United States Patent and Trademark Office

APPLICATION NO.	FILING DATE	FIRST NAMED INVENTOR	ATTORNEY DOCKET NO.	CONFIRMATION NO
10/707,035	11/17/2003	James BAECHLE	4096	1034
		EXAMINER		
CLAUSEN MILLER, P.C			CHAN, KO HUNG	
SUITE 1600 10S. LASALLE STREET			ART UNIT	PAPER NUMBER
CHICAGO, IL 60603			3632

Application No. Applicant(s) BAECHLE, JAMES 10/707,035 Office Action Summary Examiner **Art Unit** Korie H. Chan 3632 -- The MAILING DATE of this communication appears on the cover sheet with the correspondence address --**Period for Reply** A SHORTENED STATUTORY PERIOD FOR REPLY IS SET TO EXPIRE 3 MONTH(S) OR THIRTY (30) DAYS, WHICHEVER IS LONGER, FROM THE MAILING DATE OF THIS COMMUNICATION. - Extensions of time may be available under the provisions of 37 CFR 1.136(a). In no event, however, may a reply be timely filed after SIX (6) MONTHS from the mailing date of this communication. - If NO period for reply is specified above, the maximum statutory period will apply and will expire SIX (6) MONTHS from the mailing date of this communication. - Failure to reply within the set or extended period for reply will, by statute, cause the application to become ABANDONED (35 U.S.C. § 133). A

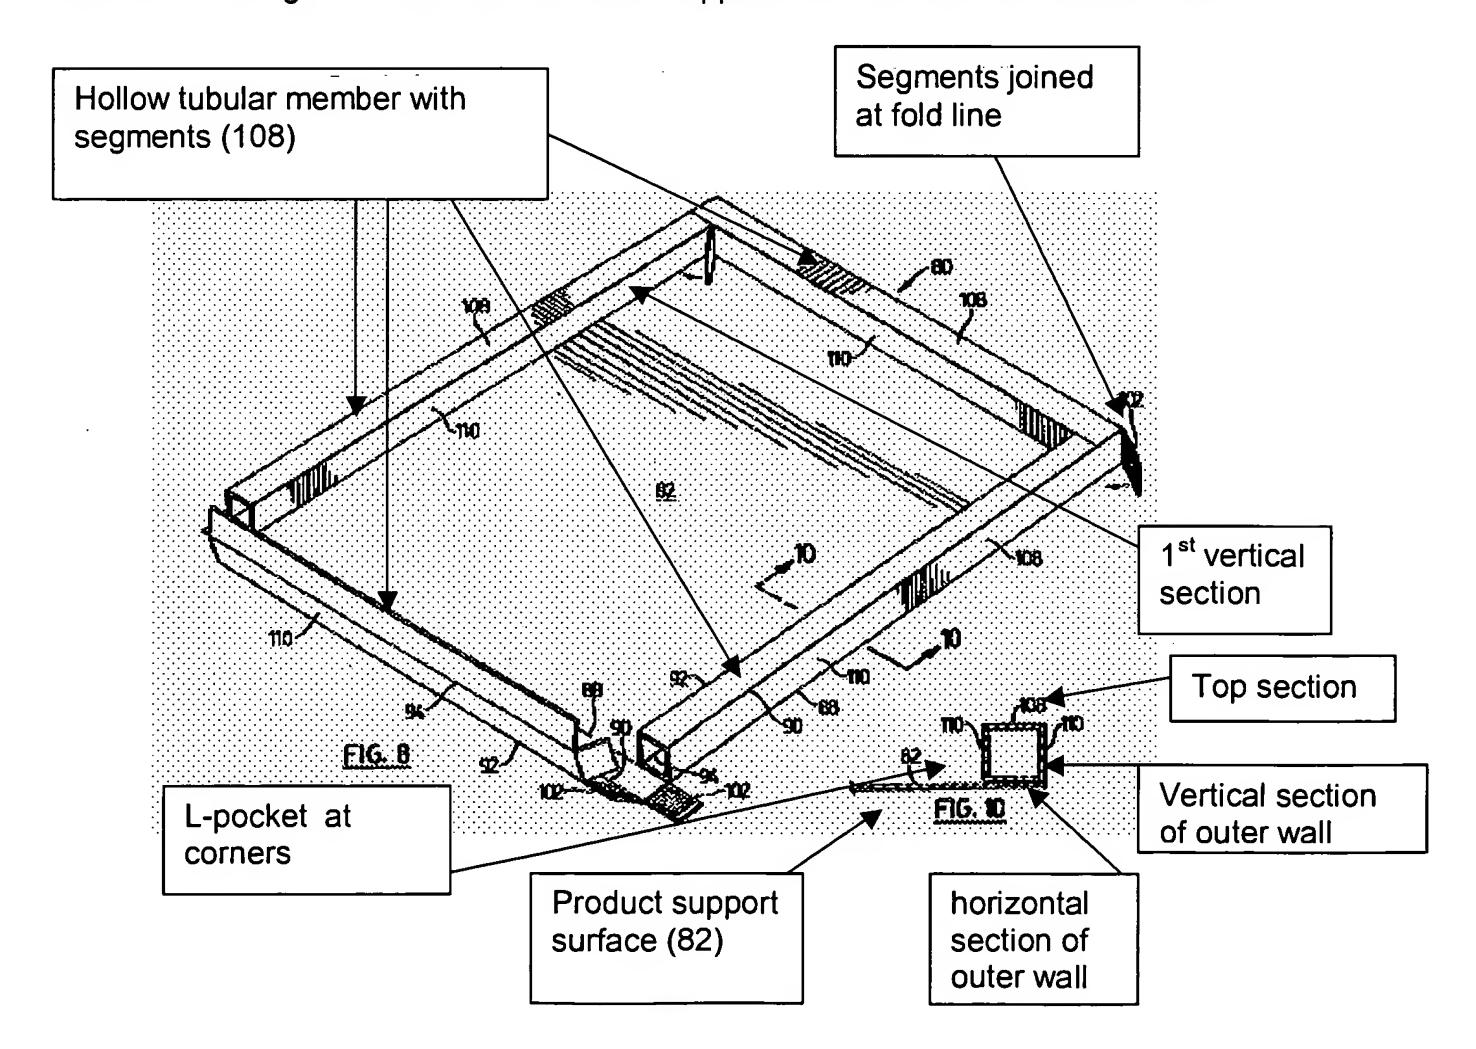
Claims 1, 2, and 4-7 are rejected under 35 U.S.C. 102(b) as being anticipated by Tarte (US patent no. 3,097,684). Tarte discloses a method of forming a hollow frame having all the claimed features of applicant's invention as illustrated below.

Regarding claim 2, Tarte shows L-shaped pockets (form by the first vertical section and the product support surface as illustrated above) in the tubular member.

Regarding claim 7, Tarte's top section is removed to form the V-shaped notch at the corners.
